IN THE DRAWING

Title: FUEL CELL HYBRID VEHICLE WITH AUTOMATICALLY
WATERED AQUEOUS BATTERIES

Inventor: Tartamella et al
Atty. Ref. 706403US1

Annotated Sheet

Fig. 1

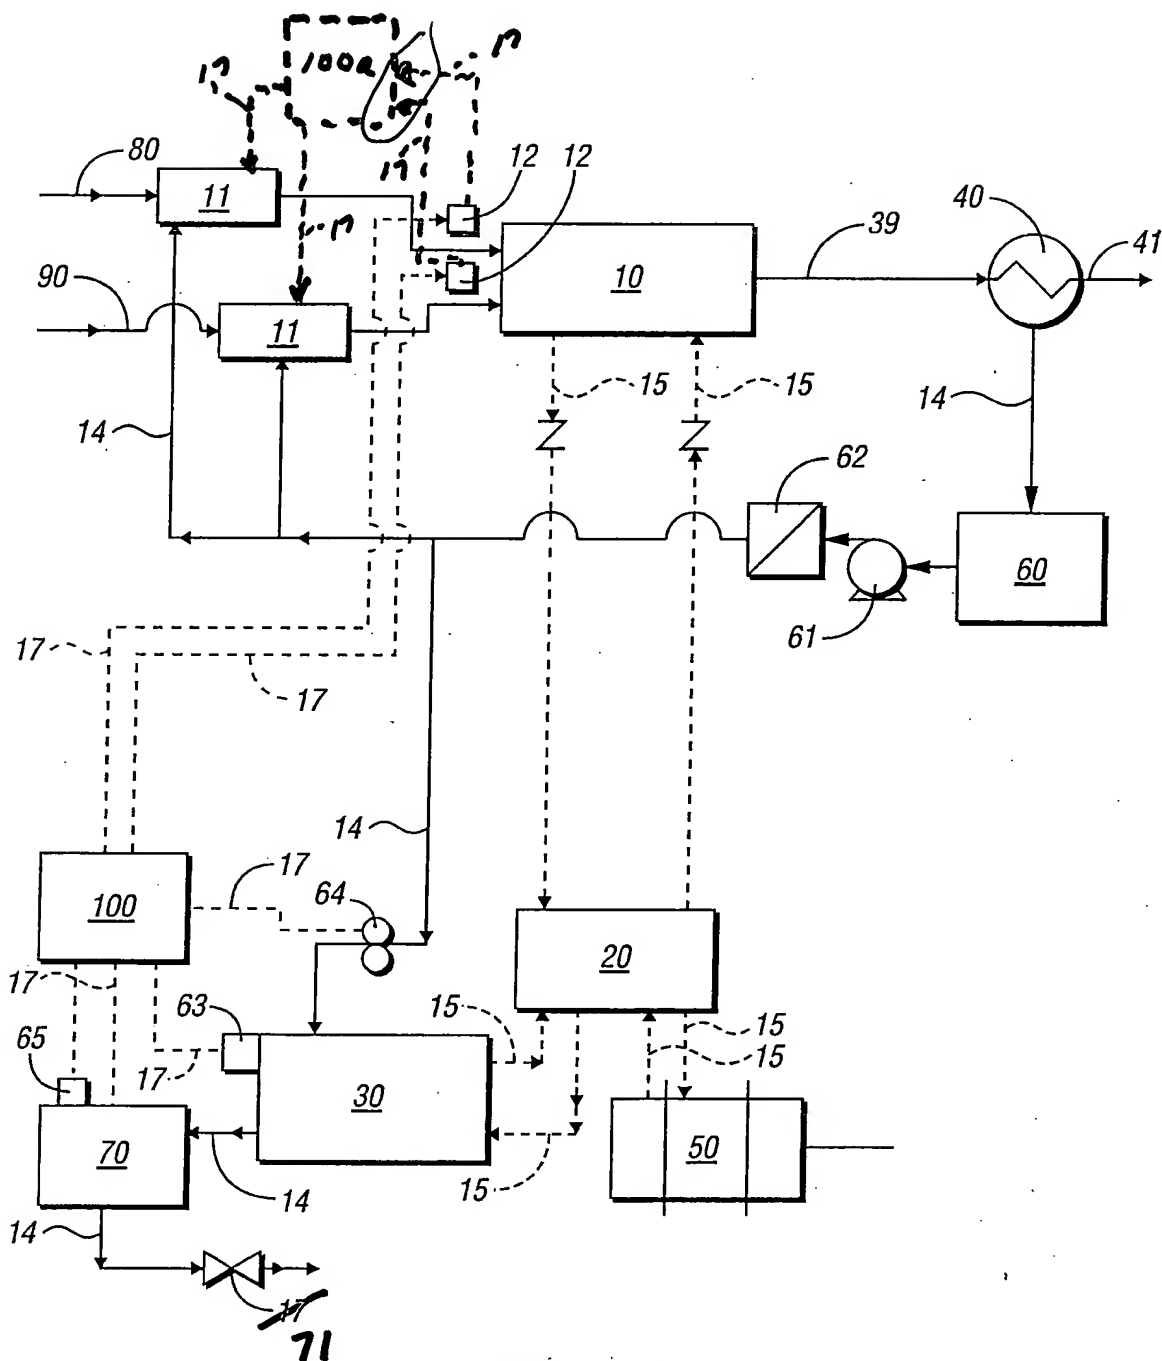
An optional second controller 100a is now shown in phantom with signal lines 17 coupling controller 100a to moisture level sensors 12 (see the specification at line 1 of page 8) and humidifiers 11. The designation of the valve coupled to overflow reservoir 70 has been changed from "17" to -71—. See the specification at page 8, lines 14—16.

Valve reference number 17 at the lower portion of Fig. 1 has been replaced with 71, consistent with the specification at lines 14—16 of page 8.

The objection to reference numeral 12 as not being mentioned in the description is

incorrect. See the specification at line 1 of page 8 regarding “moisture sensors 12.”
